Subj: Firing of the M-85 .50 Caliber Machine Gun from Onslow Beach
North Tower into the BT-3 Impact Area; comments on

Subj: Firing of the M-85 .50 Caliber Machine Gun from Onslow Beach into
the BT3 Impact Area

From: Training Facilities Officer
To: Assistant Chief of Staff, Training J. R. FRIDELL, AUG 14 1979
Subj: Request for Authorization to Fire into the BT-3 Impact Area
Ref: (a) CG 2ndMARDIV ltr 3/GSN/jnp over 1500 dtd 13 Apr 79

1. It is recommended that the request contained in reference (a) to fire into BT-3 Impact Area from the area of Onslow North Tower be disapproved.

CAMP LEJEUNE SPECIAL MAP
COMBAT TRAINING CART
APPROACHES TO NEW RIVER

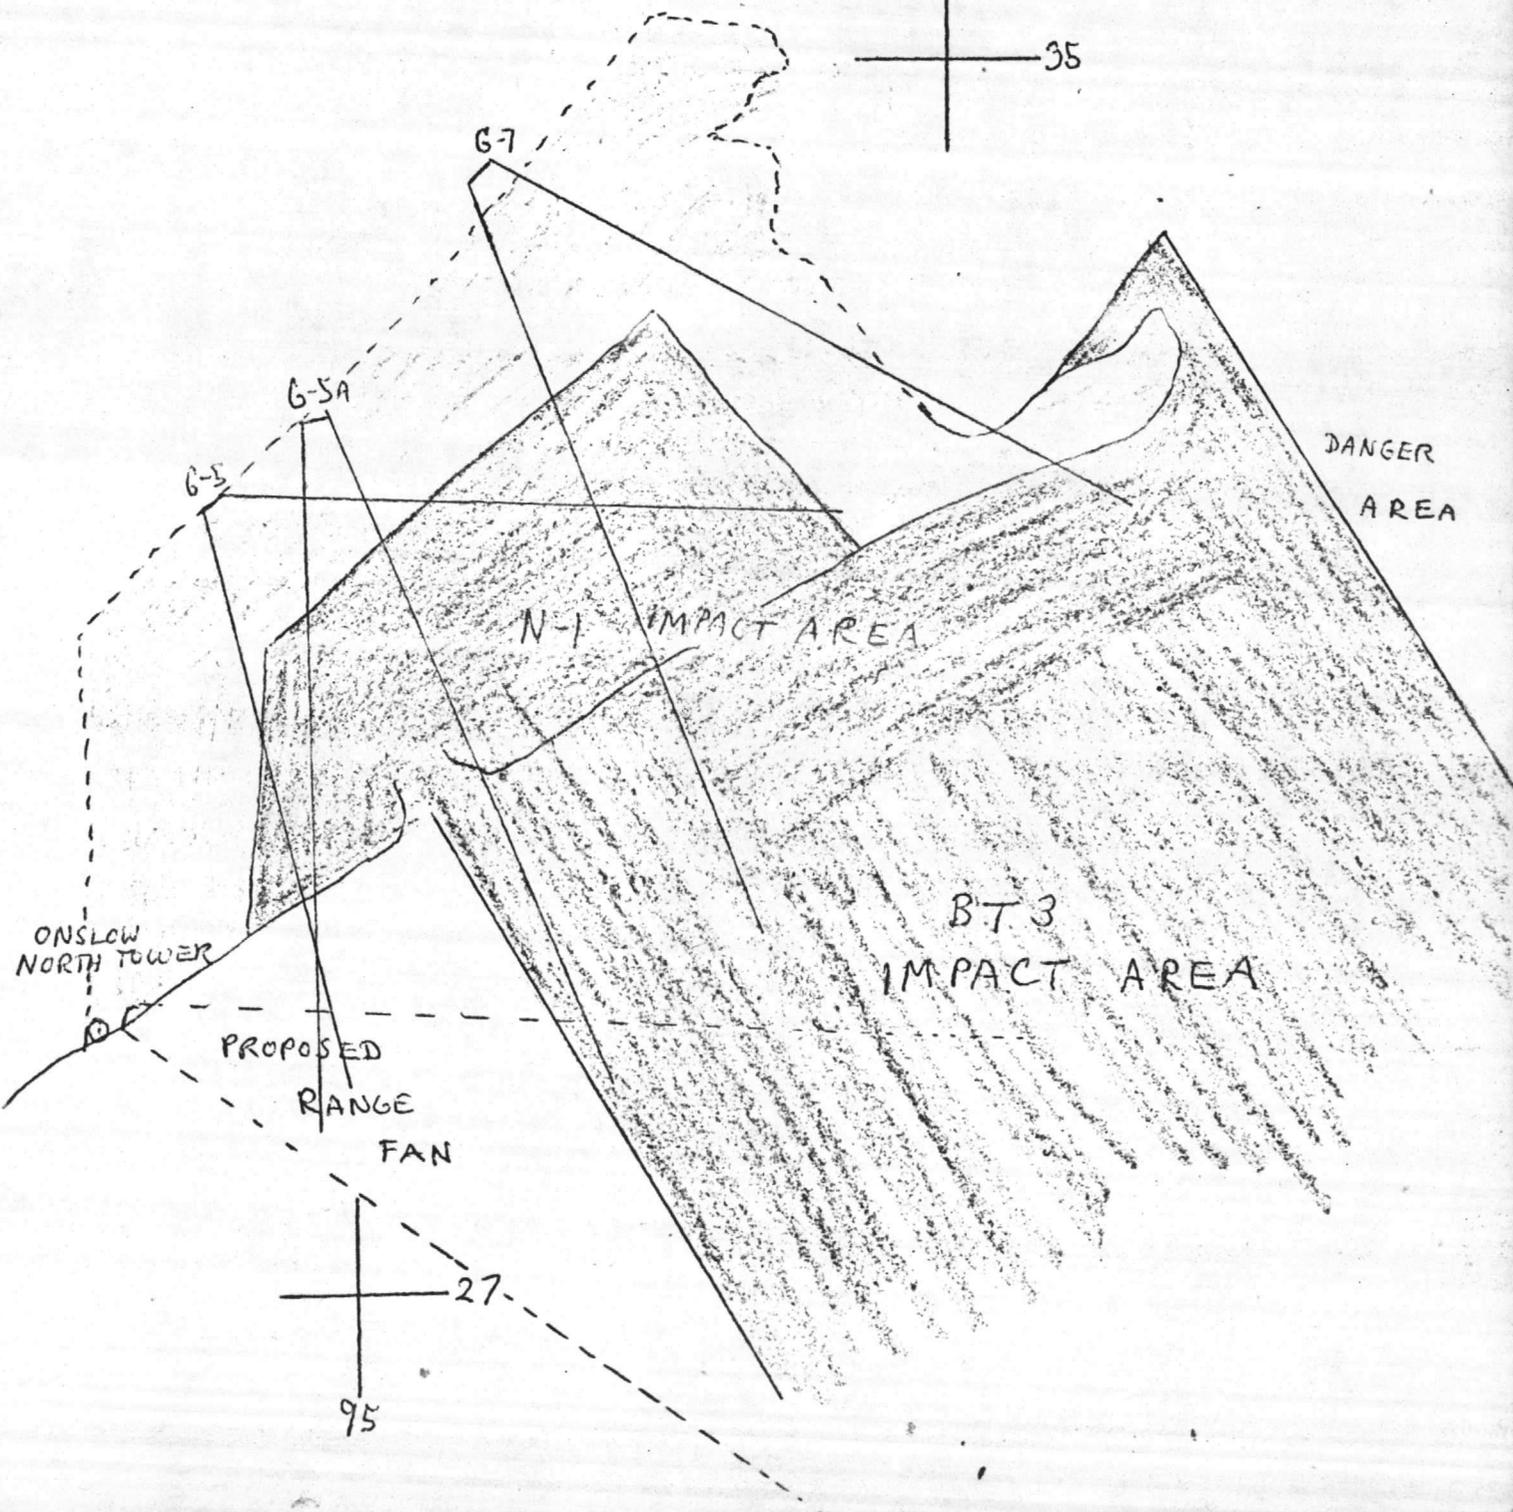
4. As a solution to the problem it is suggested that a portion of North Onslow Beach, in the immediate vicinity of Onslow North Tower, be authorized for the seaward firing of .50 caliber and 7.62mm machine guns into the BT3 impact area (see enclosure (1)).

7. According to the existing range fans (reference (b)) a firing unit set up near the base of the Onslow North Tower would not interfere with other units conducting shoots from the G-5, G-5A or the G-7 Ranges, thus permitting a greater utilization of existing ranges. Not only would these individuals be out of the line of fire, but the dunes would mask them in the event that a unit inadvertently fired outside the safety fan.

1. As per reference (a), reference (b) has been reviewed. An environmental impact assessment of the proposed action is required.
2. During reference (c) Mr. Henry advised reconsideration of the Atlantic Loggerhead Sea Turtle (*Caretta caretta*) biological opinion would be necessary.

2. The area near Onslow North Tower is in the Buffer Zone around N-1 range and is not an authorized firing position. The modification requested to the BT-3 impact area would require an Environmental Impact Assessment due to the natural habitat of the Atlantic Loggerhead Turtle, Eastern Brown Pelican, Least Tern, Dusky Seaside Sparrow, American Alligator and the basic structure of the sand dunes. Also firing the .50 caliber machine gun will possibly require increasing the limits of the BT-3 impact area.

3. The three proposed routes into Onslow North Tower are marginal at best. Routes "a" and "b" are both unacceptable as they go through the recreational areas along the ocean front. Route "c" would take as much time from actual firing as the boats going up and down the waterway, and have an adverse effect on the beach.

CAMP LESEUNE SPECIAL MAP
COMBAT TRAINING CHART
APPROACHES TO NEW RIVER
SCALE 1:50,000

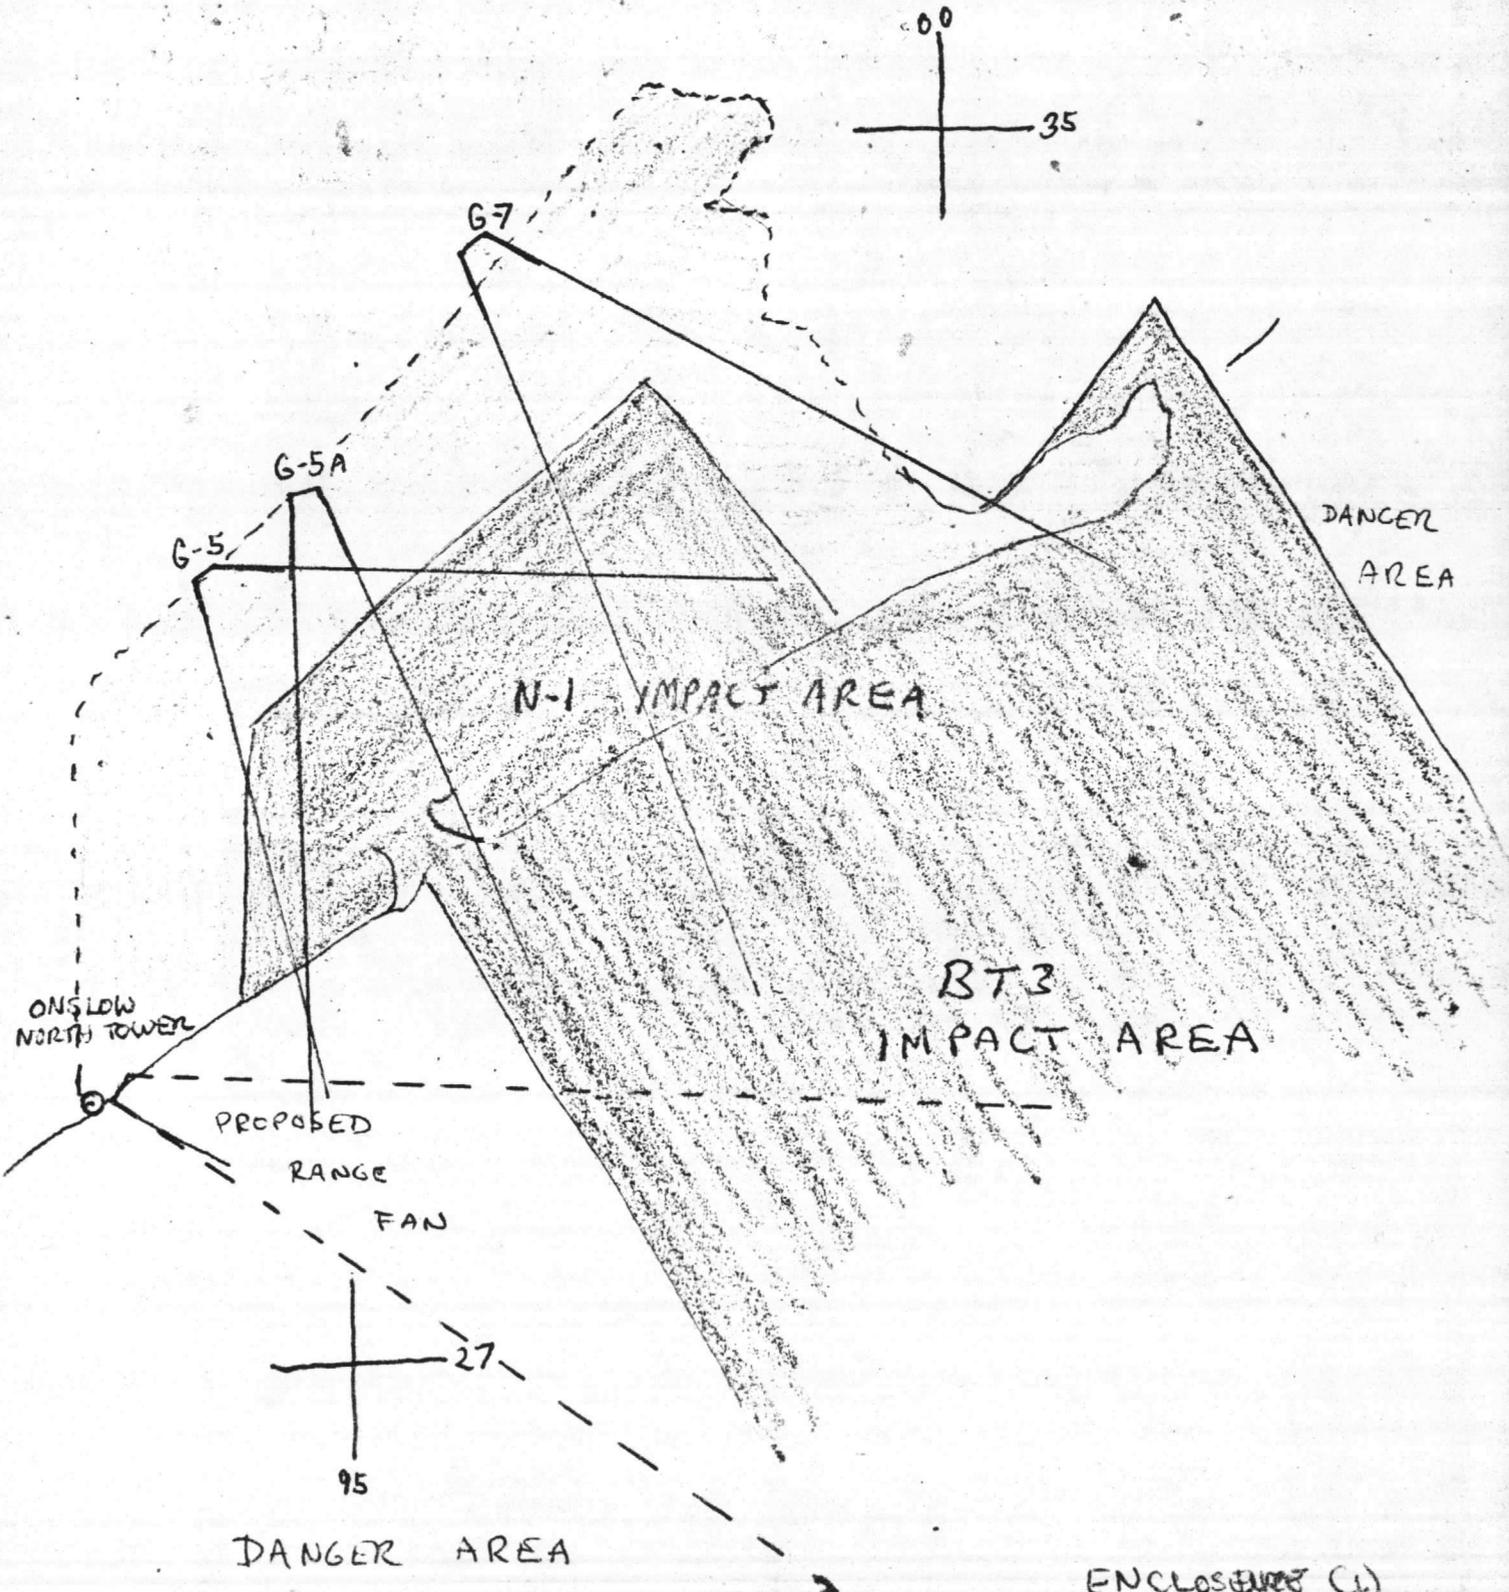
4. As a solution to the problem it is suggested that a portion of North Onslow Beach, in the immediate vicinity of Onslow North Tower, be authorized for the seaward firing of .50 caliber and 7.62mm machine guns into the BT3 impact area (see enclosure (1)).

7. According to the existing range fans (reference (b)) a firing unit set up near the base of the Onslow North Tower would not interfere with other units conducting shoots from the G-5, G-5A or the G-7 Ranges, thus permitting a greater utilization of existing ranges. Not only would these individuals be out of the line of fire, but the dunes would mask them in the event that a unit inadvertently fired outside the safety fan.
